**Amendments to the Drawings:**

## REMARKS AND ARGUMENTS

### Drawings

FIG. 4

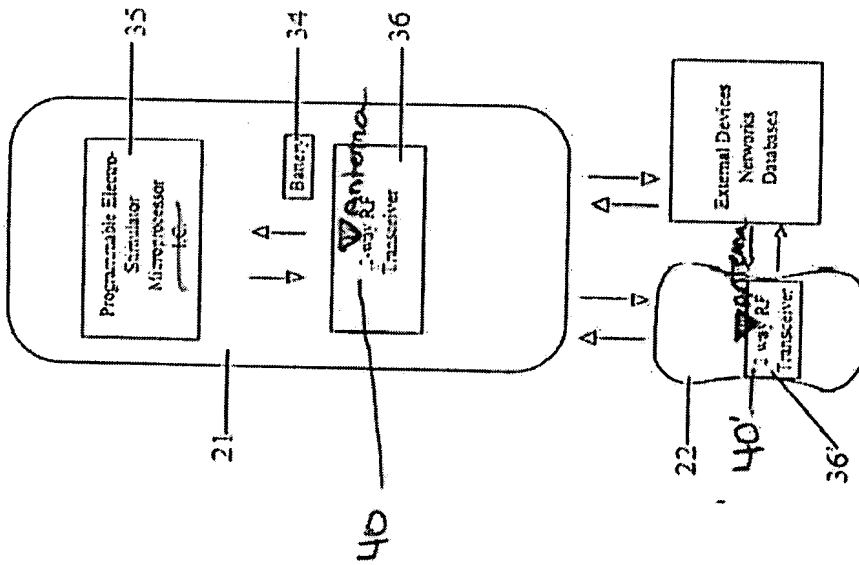
The attached sheet of drawings includes changes to Fig. 4, 5 and 6. These drawing sheets, which includes Figs. 4, 5 and 6, completely replace the original sheets including Figs 4, 5 and 6. In these Figs., omitted elements 40 and 40' have been added. In addition, some of the wording has changed within the drawings.

Three replacement drawing sheets in compliance with 37 CFR § 1.121(d) are submitted herewith. Replacement Figures 4, 5, and 6 each show an antenna (40) as an element of the probe unit and an antenna (40') as an element of the control unit.

Additionally, in each of the replacement drawing sheets, "I.C." has been deleted from the label of the representation of the microprocessor (35) of the probe unit (21) because this part of the label was not sufficiently explained in the written description.
